Santa Maria Airport	Change Order No. 1
	US Customs Upgrades: Building and Site Civil	September 25, 2024

RFI #9: Shutoff for Domestic Water Line Entry

RFI #10: Weep Screed at Exterior Stucco Walls

RFI #19: Existing Ducting Clashing with New Lighting

M2.0
SHEET 13 OF 23

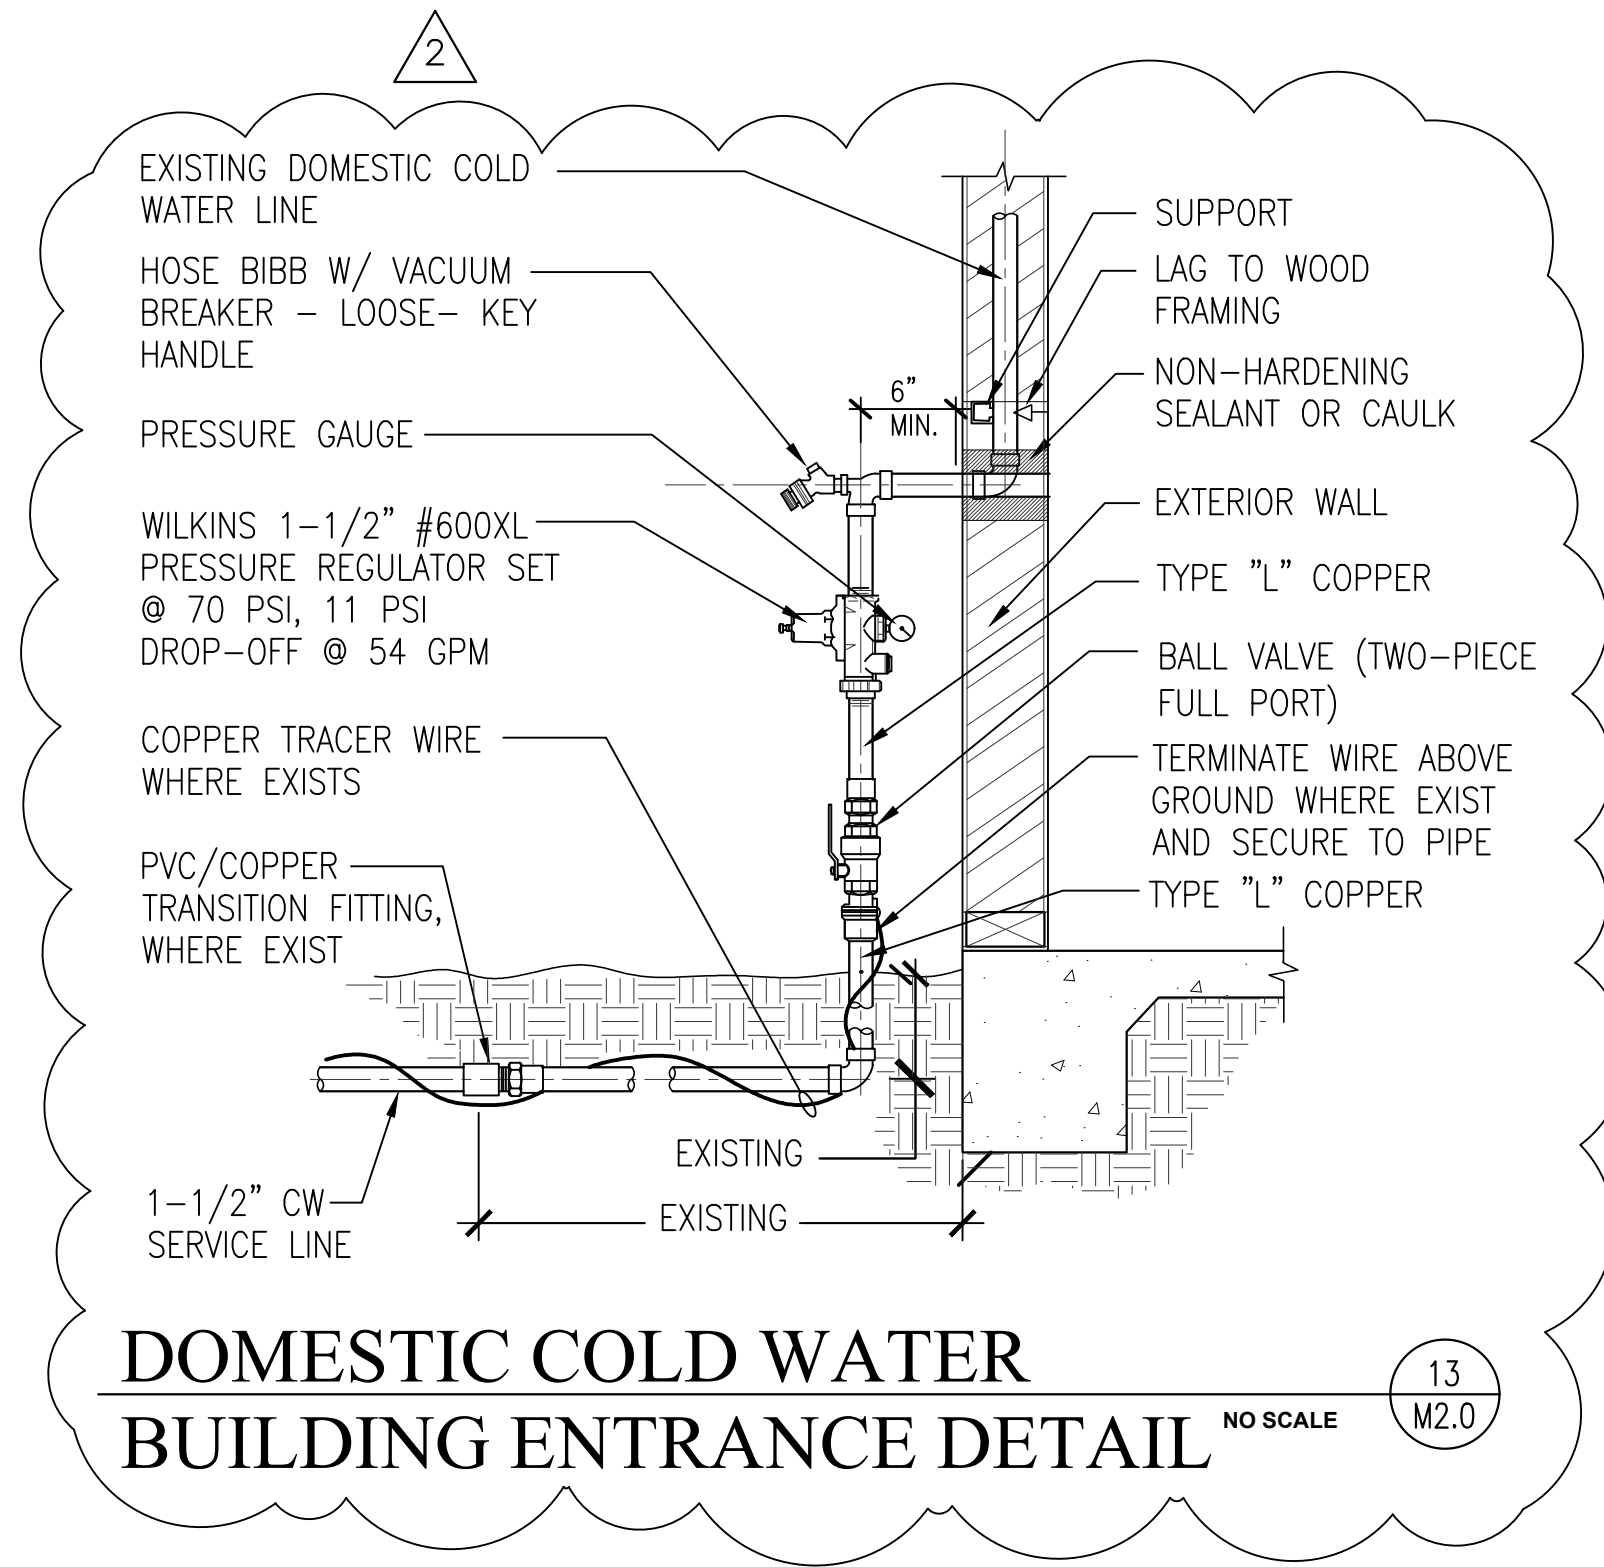
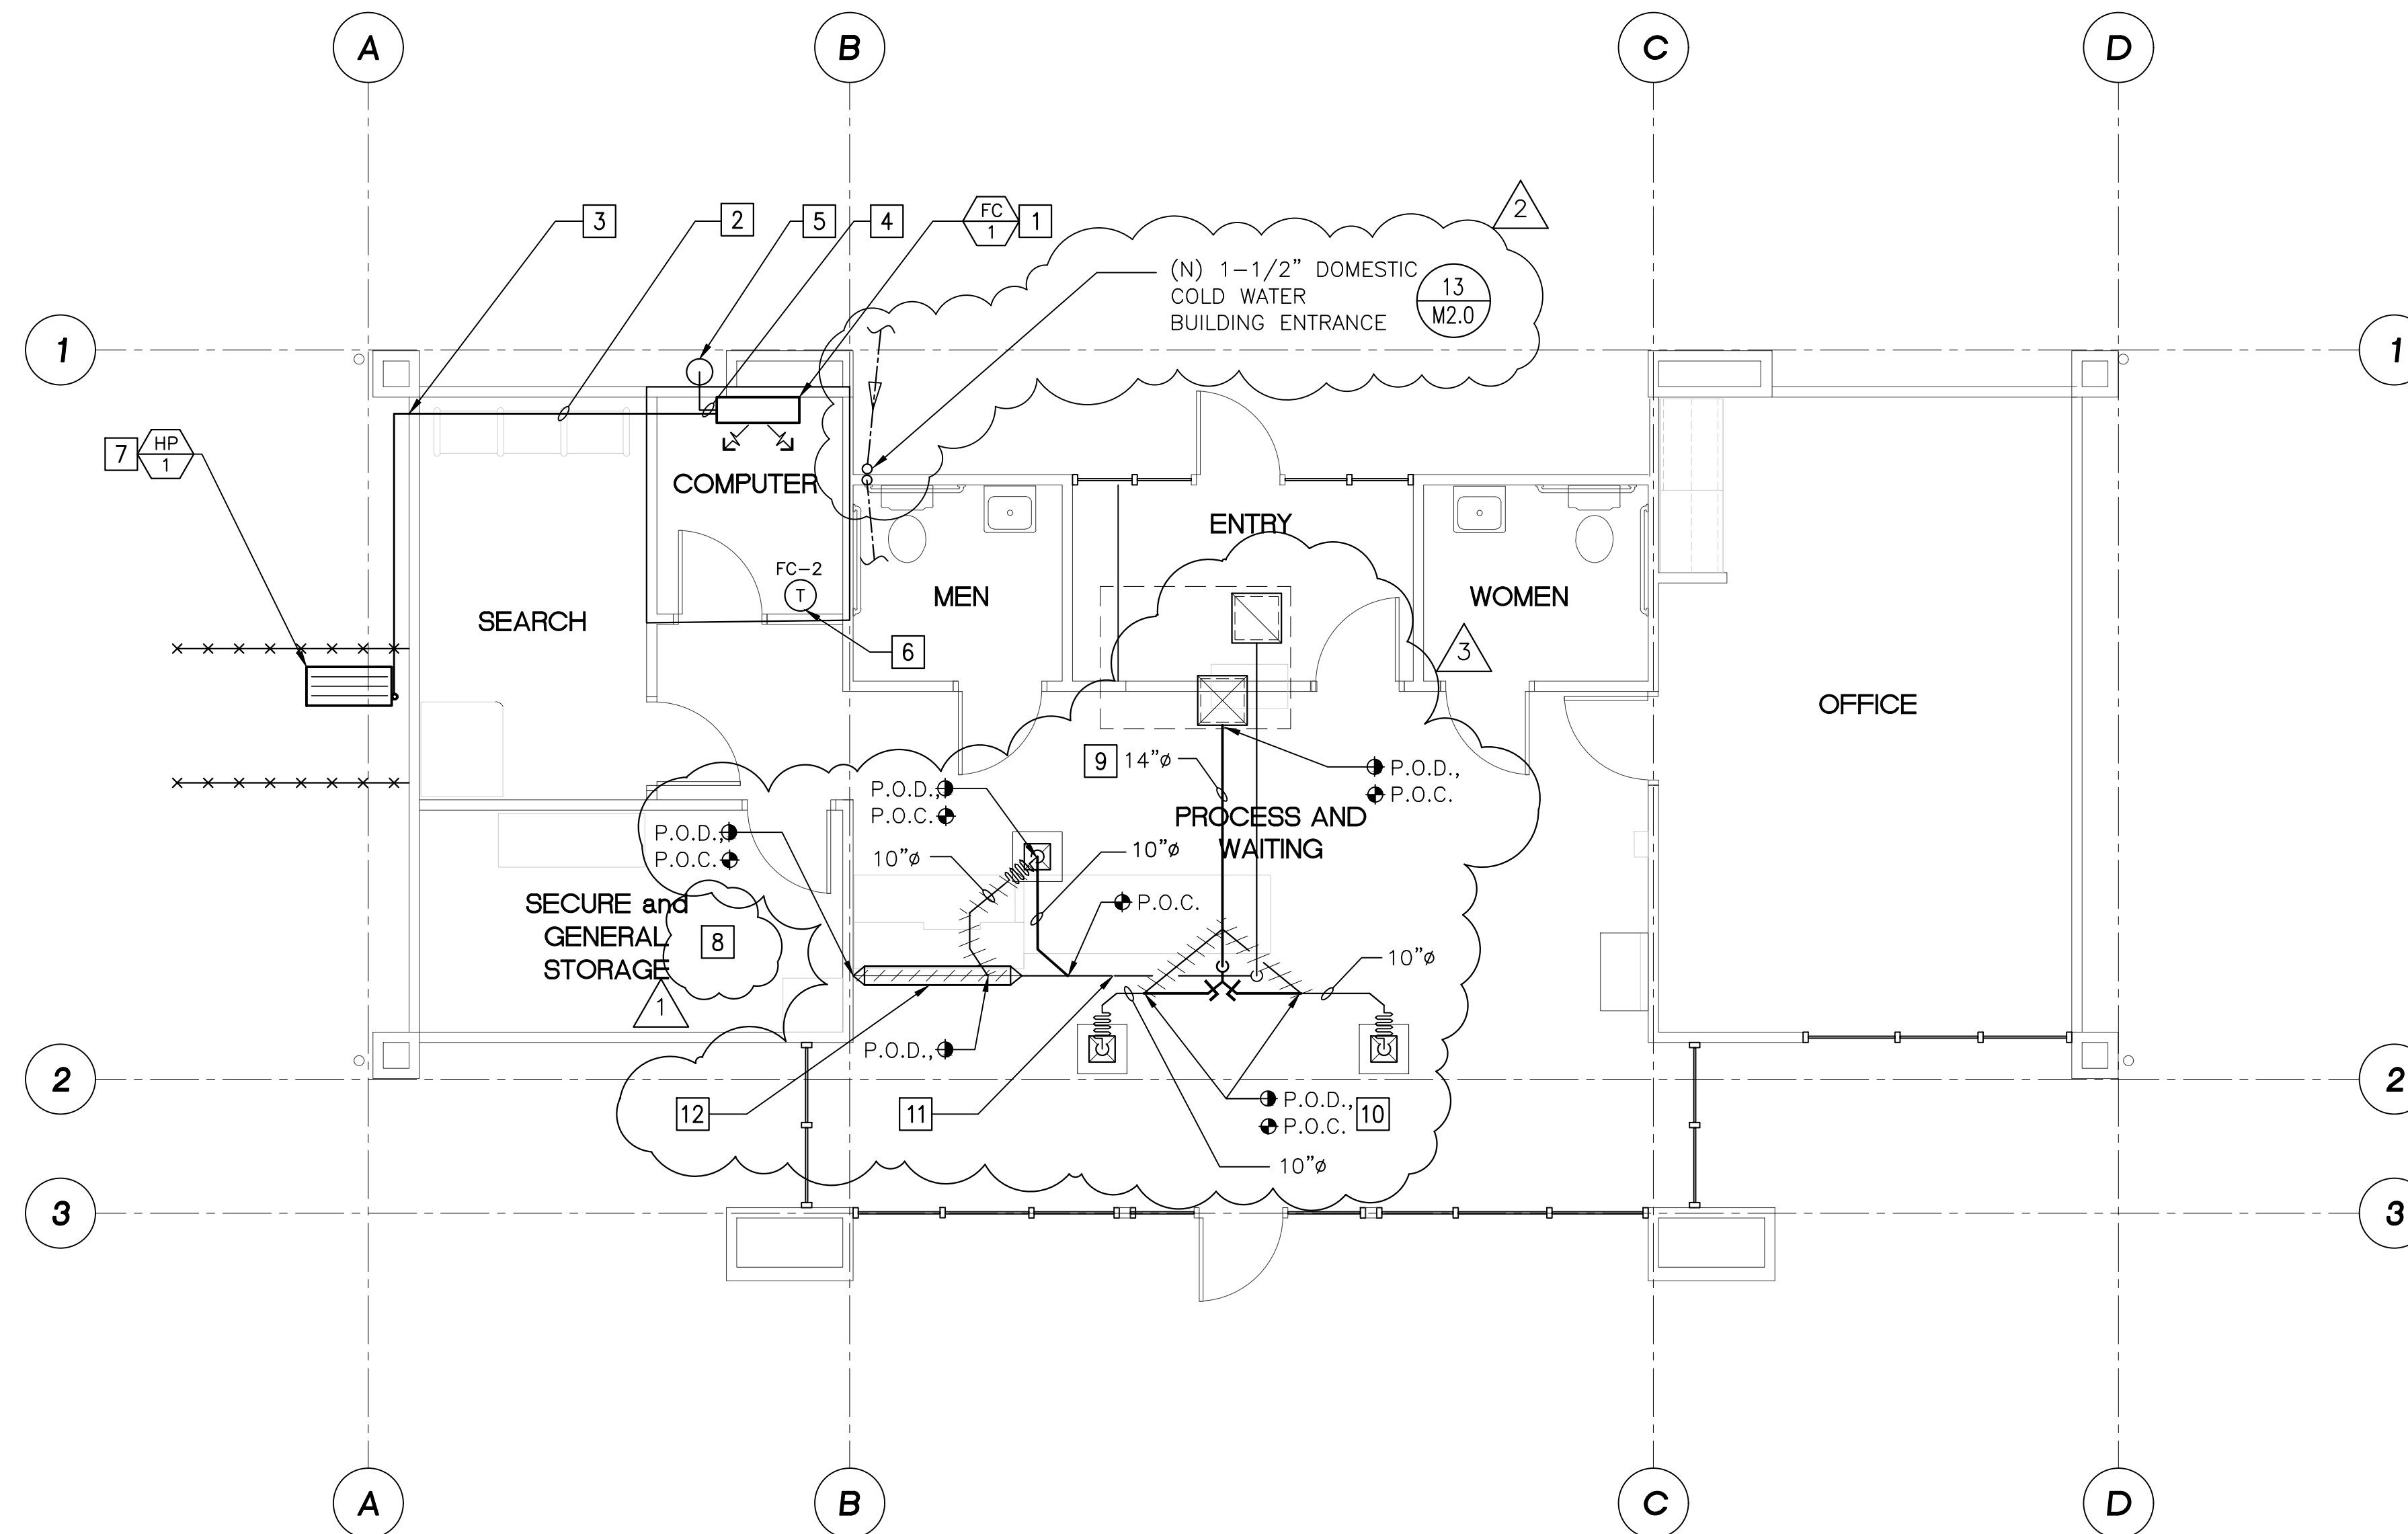
Per the attached photo, the point of entry for the domestic main water line does not have a shut off valve or pressure regulator. Please confirm if one or both of these items is to be added and provide specifications for submittal purposes.

See revised drawing sheet M2-0, Revision 2. Add new shut off valve, pressure regulator and hose bib/building drain valve per detail.

- 1 WALL MOUNTED FAN COIL UNIT. INSTALL PER DETAIL 13/M5.0.
- 2 REFRIGERANT LINES TO CONDENSER. HANG ABOVE CEILING PER DETAIL 12/M5.0.
- 3 REFRIGERANT LINES TO PENETRATE WALL PER DETAIL 21/M5.0.
- 4 TYPE "M" COPPER CONDENSATE DRAIN LIE, MAINTAIN 1/8" DROP PER 1' TRAVEL. SIZE PER MANUFACTURE RECOMMENDATION. HANG SIMILAR TO DETAIL 12/M5.0.
- 5 CONDENSATE LINE TO TERMINATE IN A DRYWELL IN PLANTER BOX OUTSIDE. SEE DETAIL 23/M5.0.
- 6 COORDINATE NEW THERMOSTAT SET POINT WITH SANTA MARIA AIRPORT DISTRICT OFFICE IT DEPARTMENT TO ENSURE PROPER ROOM TEMPERATURE.
- 7 NEW COOLING ONLY CONDENSING UNIT ON PRE-MANUFACTURED PRECAST CONCRETE PAD OUTSIDE. SEE DETAIL 14/M5.0 FOR MOUNTING.

- 8 REMOVE EXISTING SUPPLY AND RETURN GRILLE AND RE-INSTALL FOLLOWING INSTALLATION OF NEW CEILINGS. REMOVE EXISTING 8" SUPPLY AND RETURN DUCTS THROUGH NEW METAL MESH WALL SECURITY PANELS TO SERVE RE-INSTALLED GRILLES. NOTE: MAXIMUM OPENING SIZE THROUGH MESH IS 9-1/2" x 9-1/2".

- 9 RAISE EXISTING SUPPLY DUCT UP TO BETWEEN ROOF JOIST - SIMILAR TO RETURN DUCT.
- 10 RELOCATE EXISTING BRANCH DUCTS.
- 11 RAISE EXISTING RETURN DUCT UP TO BOTTOM OF ROOF JOISTS.
- 12 REPLACE EXISTING 12"Ø DUCT WITH 16"x8" DUCT, THIS AREA.

Rough-In (One Station); Plumbing and Electrical, Front View

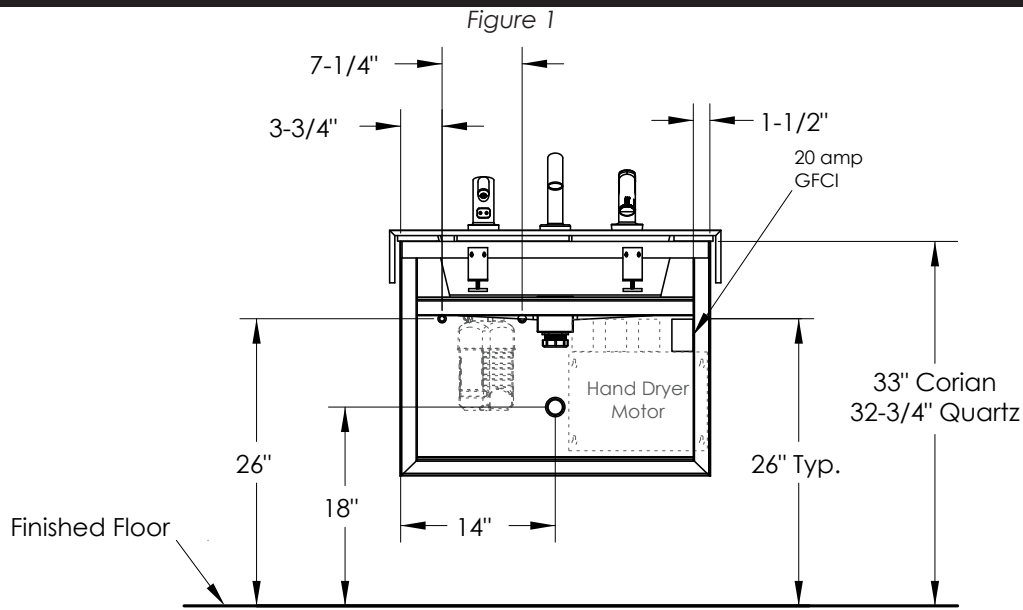
Question	<p>Question from Jeremy Tennesen Pac-West General on Friday, Aug 2, 2024 at 09:06 AM PDT</p> <p>The bathroom sinks selected for the project have built in hand dryers that require power to be fed to them. Please confirm power accommodations for hand dryers.</p>
Official Response	<p>Response from Jim Albrecht RA Architects & Engineers on Monday, Aug 19, 2024 at 07:20 AM PDT</p> <p>Provide new 20 amp , 1 pole circuits with 2 #12 and 1 #12 ground in 1/2 Conduit from Panel A, 1 per hand dryer. Utilize existing circuits and circuit breakers (example 5, 6) made spare from installation of panel A-UPS. Provide receptacles or hard wire connection per hand dryer manufacturer's instructions. Include designation of new hand dryer circuits on updated panel schedule card.</p>
All Replies	<p>Response from Jim Albrecht RA Architects & Engineers on Monday, Aug 19, 2024 at 07:20 AM PDT</p> <p>Provide new 20 amp , 1 pole circuits with 2 #12 and 1 #12 ground in 1/2 Conduit from Panel A, 1 per hand dryer. Utilize existing circuits and circuit breakers (example 5, 6) made spare from installation of panel A-UPS. Provide receptacles or hard wire connection per hand dryer manufacturer's instructions. Include designation of new hand dryer circuits on updated panel schedule card.</p>

- Hand Dryer Motor alone, without heater option activated, is only 500 watts or less with speed control.
- Hand Dryer with Heater requires 1500 watts or less with speed control.

- Each Hand Dryer Motor must be plugged into a dedicated 20 amp GFCI safety circuit. 20 amp electrical cutout shown as solid lines.
- Other electrical cutouts (dotted lines) are shown for reference only, to allow for multiple 15 amp (or less) plug-in components. The number of circuits required will vary depending on the quantity of outlets needed to support the electrical requirements of these components.
